Your Ref. : TPB/A/YL-KTS/988  
Our Ref. : PSL/REL/20240304(6) - DD 113 LOT 475, KAM TIN, YUEN LONG

**Submission of Further Information**  
**S.16 Application for**  
**Proposed Temporary Animal Boarding Establishment for a Period of 5 Years**  
**In "Agriculture" Zone, Lot 475 in DD 113, Kam Tin, Yuen Long, New Territories**  
**Planning Application No. A/YL-KTS/988**

## Drainage Proposal & Related Supporting Documents

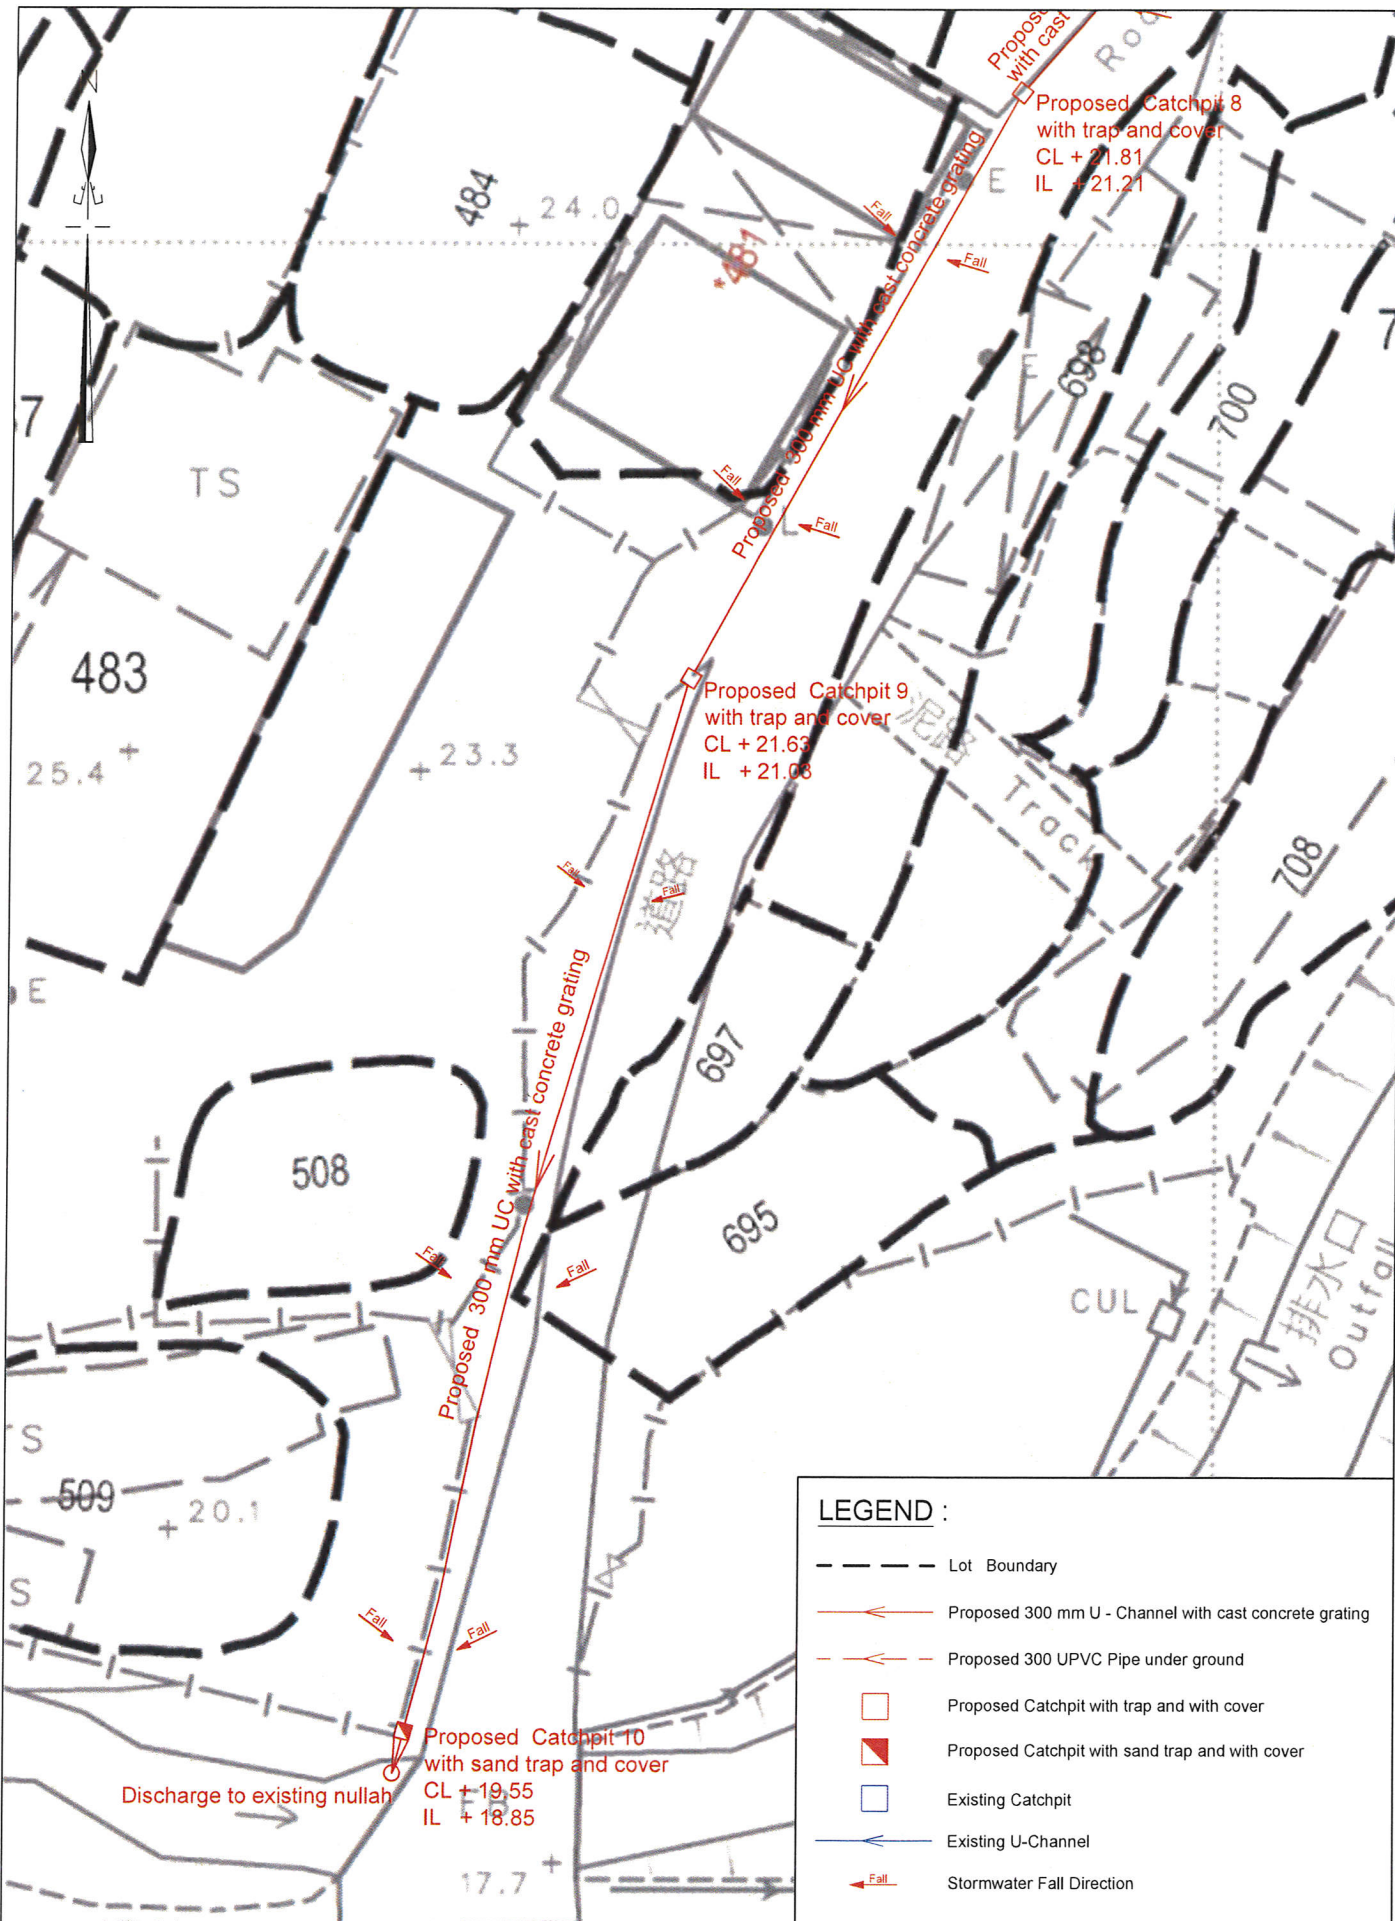
1. Please refer to the plans.
2. Please refer to the calculations.
3. Please refer to the calculations.
4. We are responsible for handling and resolving any conflict/disagreement arisen for discharging the runoff from the application site(s) to the proposed discharge point(s). We ensure that this drainage system and the existing downstream drains/channels/streams have adequate capacity to convey the additional runoff from the application site(s). We will perform regular maintenance to ensure that the drainage system does not get blocked.

5. Please refer to Proposed Catchpit 10 and it is a sand trap.
6. The application site will have a hoarding built in the future, with an approximate 200 mm gap from the ground.

8. Please refer to the plans.
